Exhibit “A”

September 19, 2023

RE: Completeness Review of Cornelius South Commercial Type III Site Design Review and Type II Preliminary Land Partition

C050

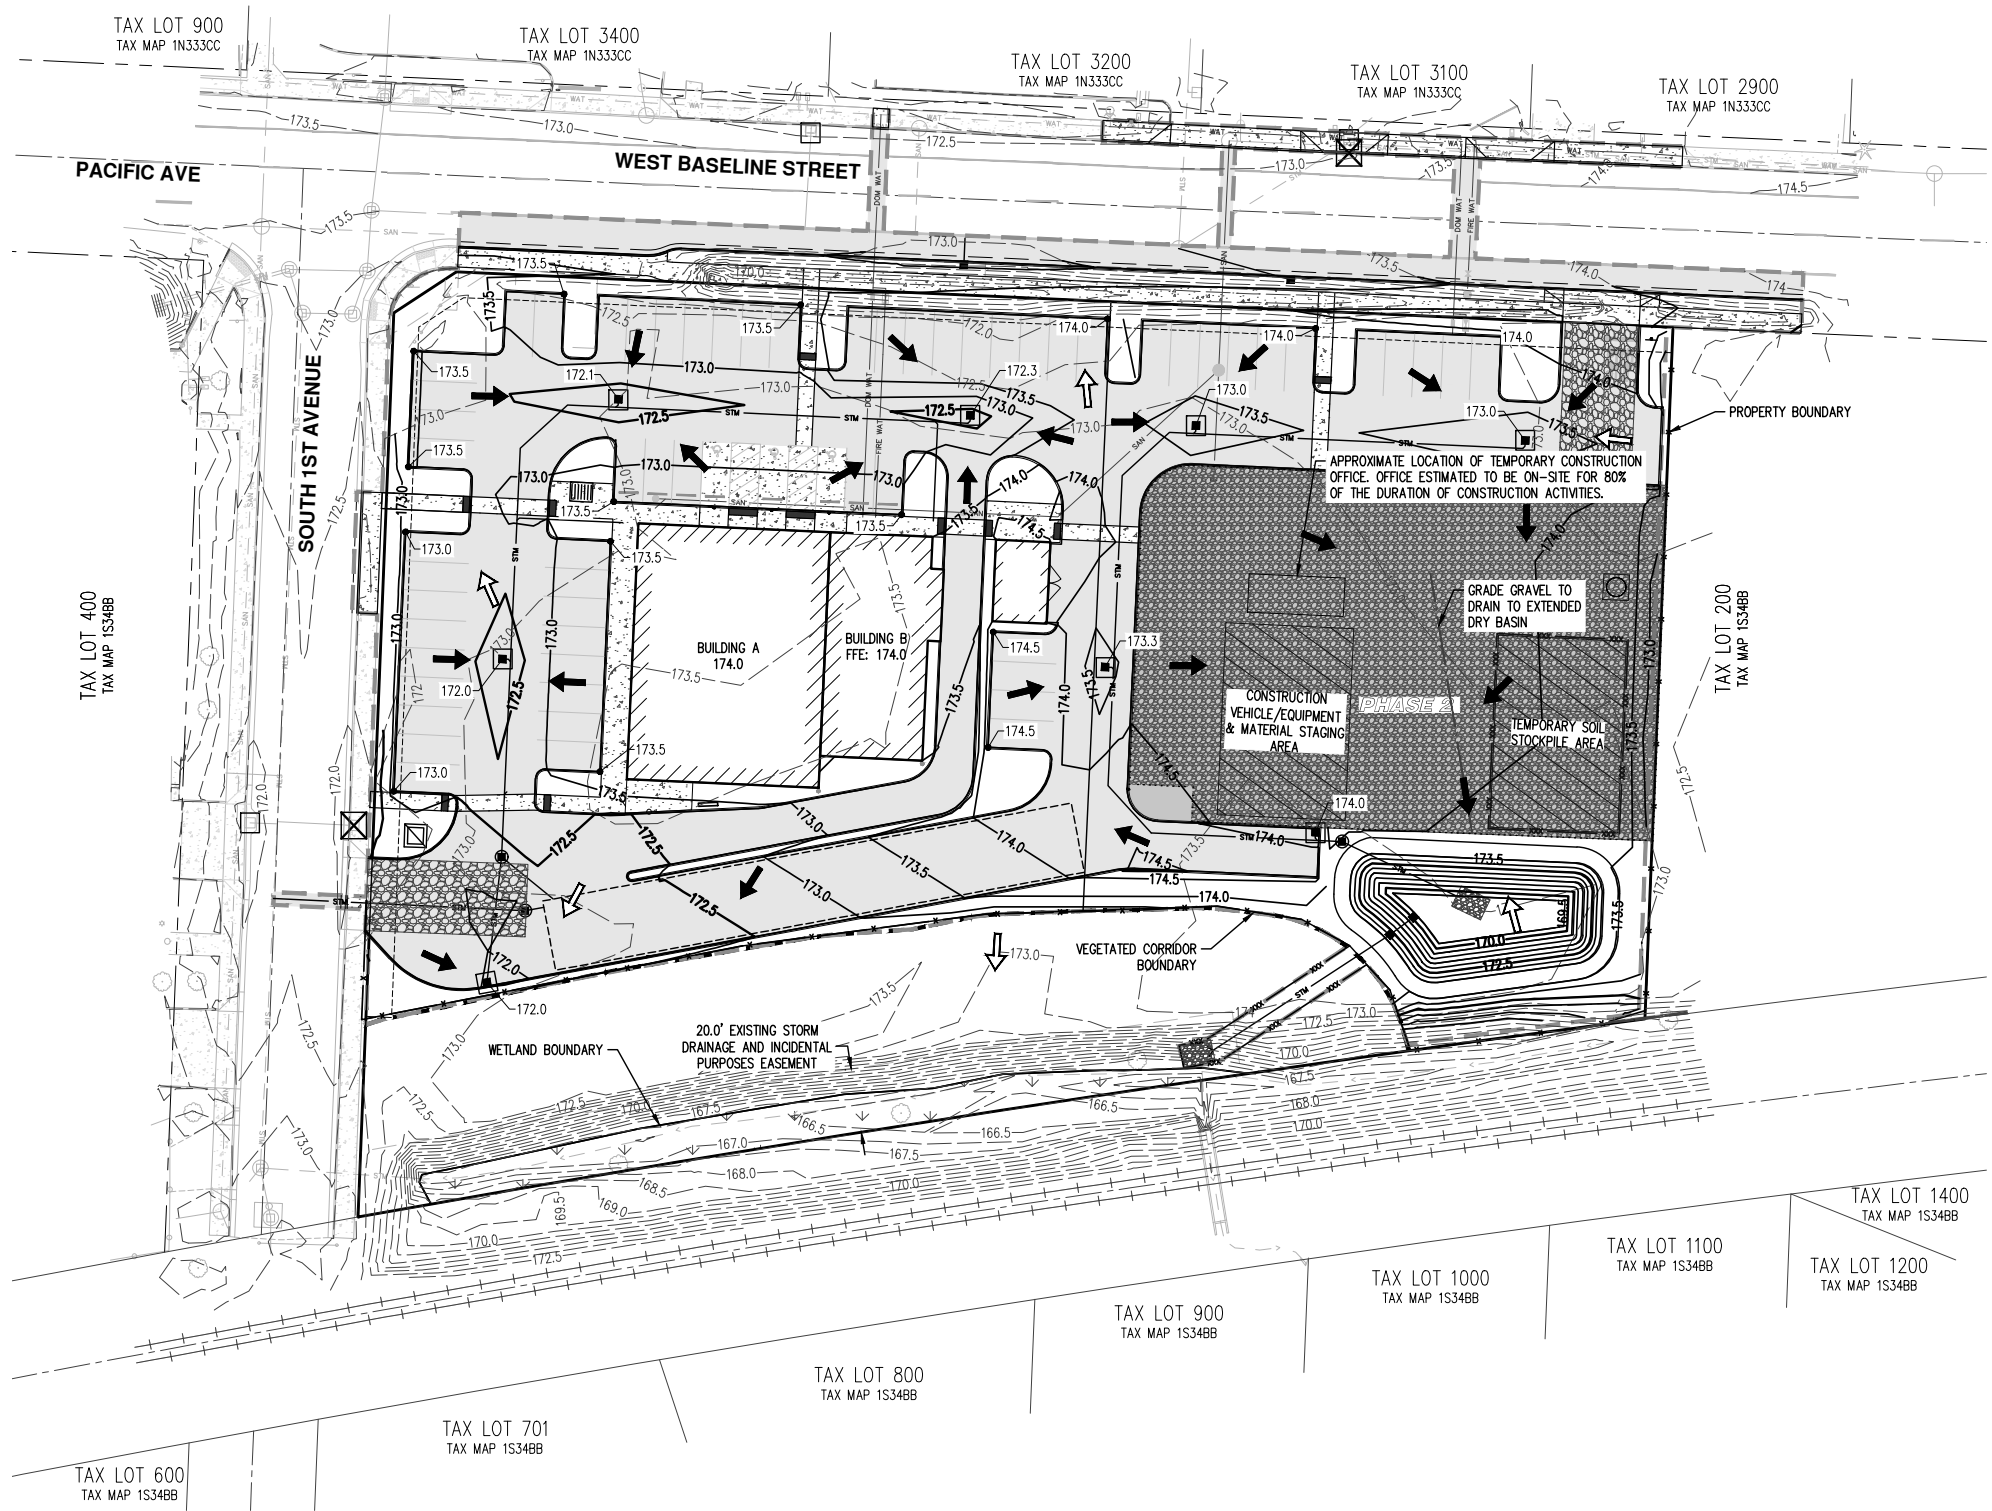
5. *Please demonstrate the required 10-vehicle reservoir requirement within the drive-thru lane. (If a menu board or height bar is proposed at the entrance of the drive-thru, staff recommends including these details, within the application packet.)*

Response: A diagram depicting the 10-space queuing reservoir is included on Sheet C100 in the updated Preliminary Plans (Exhibit A). The planned location of the menu board and height bar are shown on Sheet C100 and can be further assessed upon building permit review.

1 FENCE DETAIL
0" 1/4" 1/2" 1" 2" 3" 1" = 1'-0"

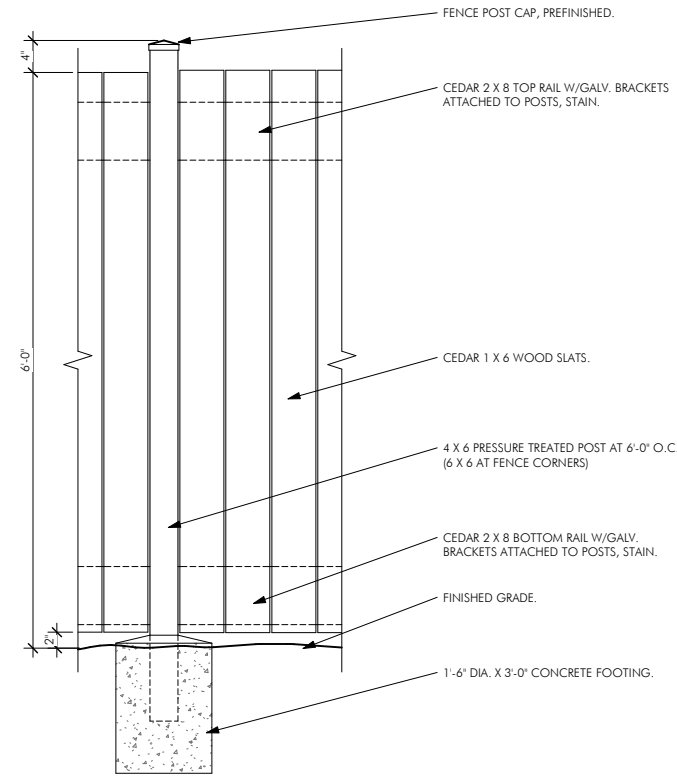
4. *Provide details [for] the proposed fencing. Please note, it is difficult to ascertain the location of the new fencing, per Sheet C100 Detail #20.*

Response: Additional details of the planned fencing are included with the updated Preliminary Plans (Exhibit A). See Sheet C100 for the location and Sheet A1.21 for the fencing detail.

2 INVERTED U BIKE RACK DETAIL
0" 6" 1" 2" 3/4" = 1'-0"

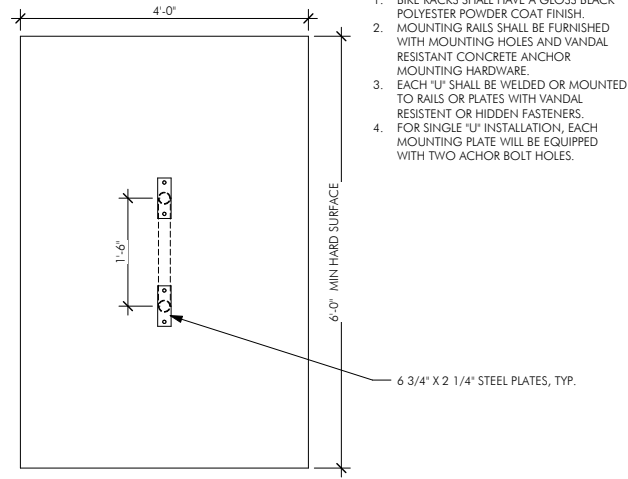
3. *Provide details for the proposed bicycle parking.*

Response: Details for the planned bicycle parking are included with the updated Preliminary Plans (Exhibit A) and discussed in the updated narrative. See Sheet A.1.02 for the bike rack details.

1 TRASH ENCLOSURE - FRONT ELEVATION

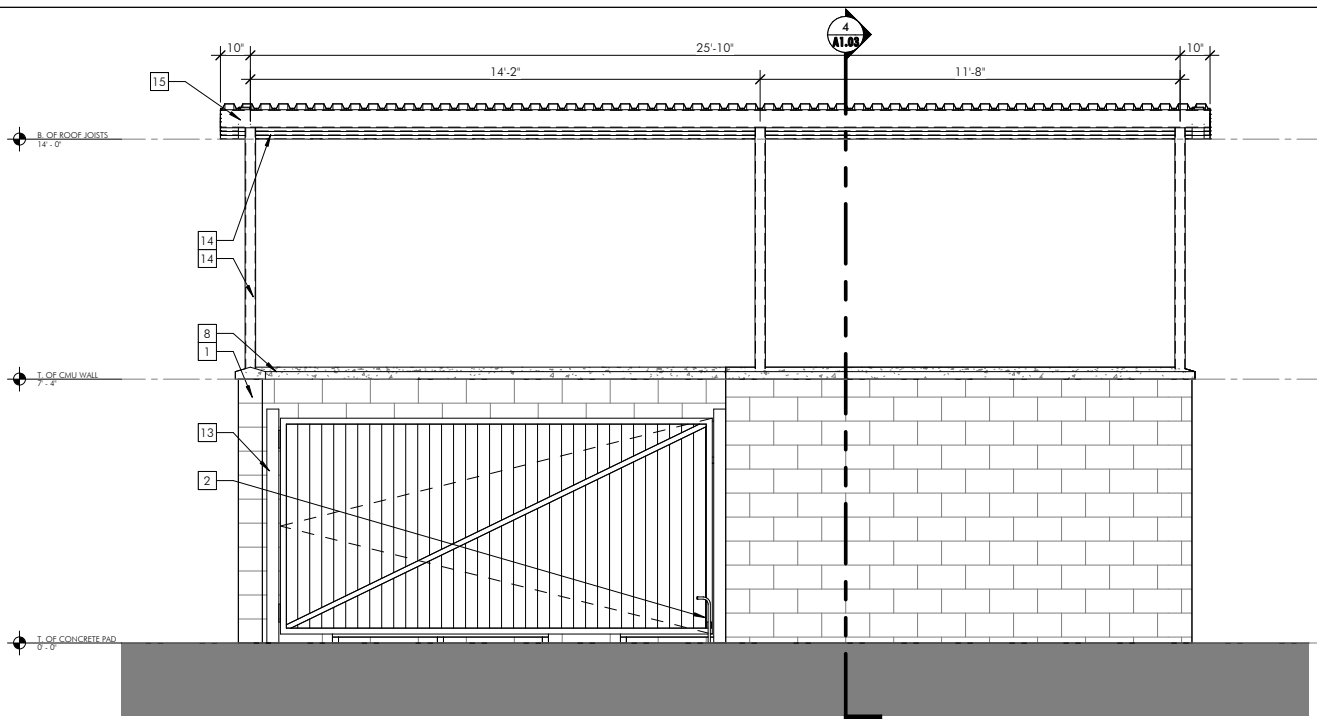
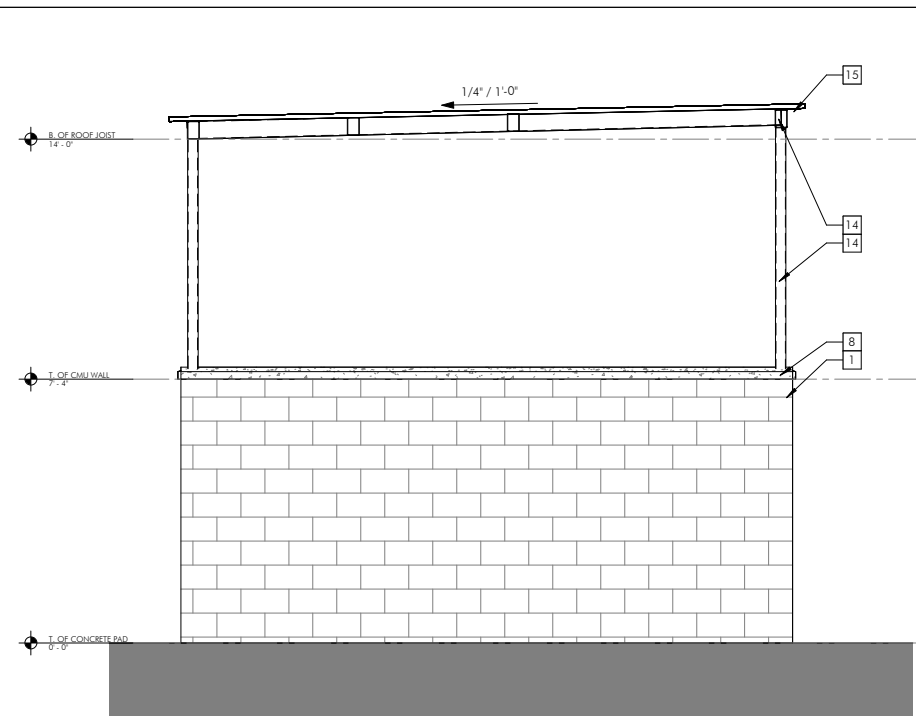
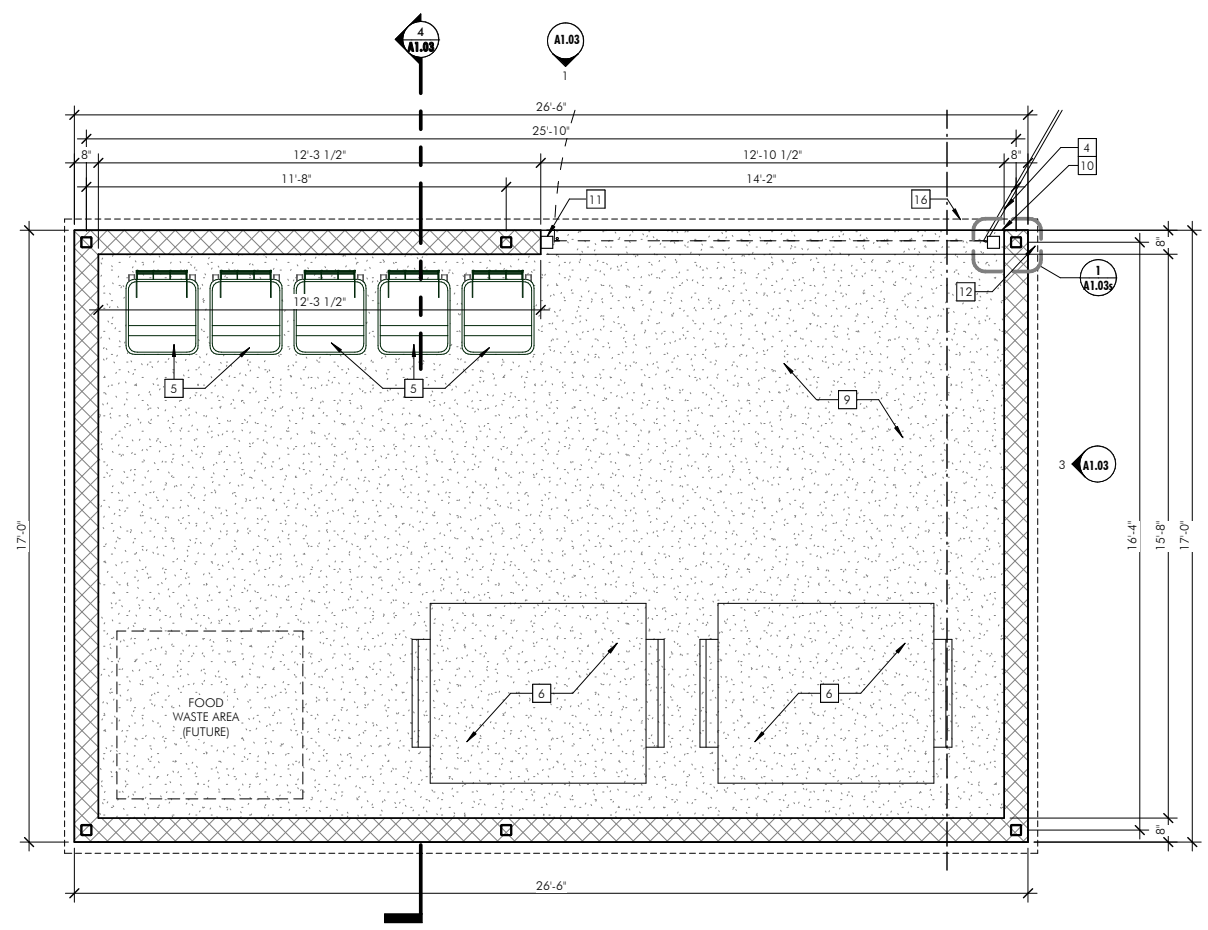
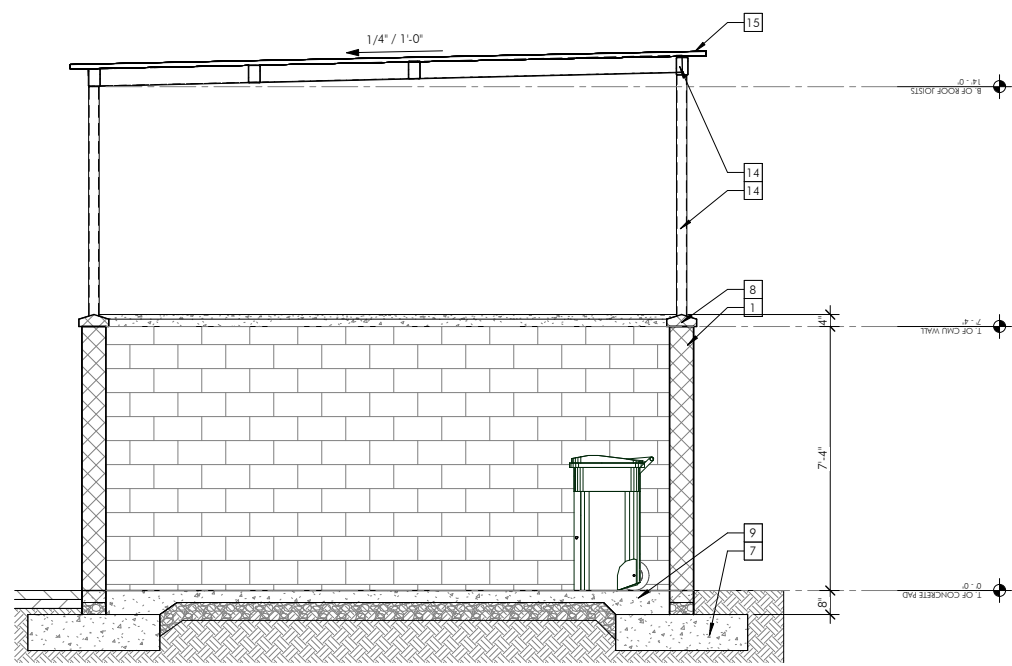
2. *Provide details for the proposed trash enclosure, including food waste enclosure for the restaurant (see CMC 5.60).*

Response: Details for the trash enclosure are included with the updated Preliminary Plans (Exhibit A). Sheet A1.03 identifies the food waste area in the covered enclosure area.
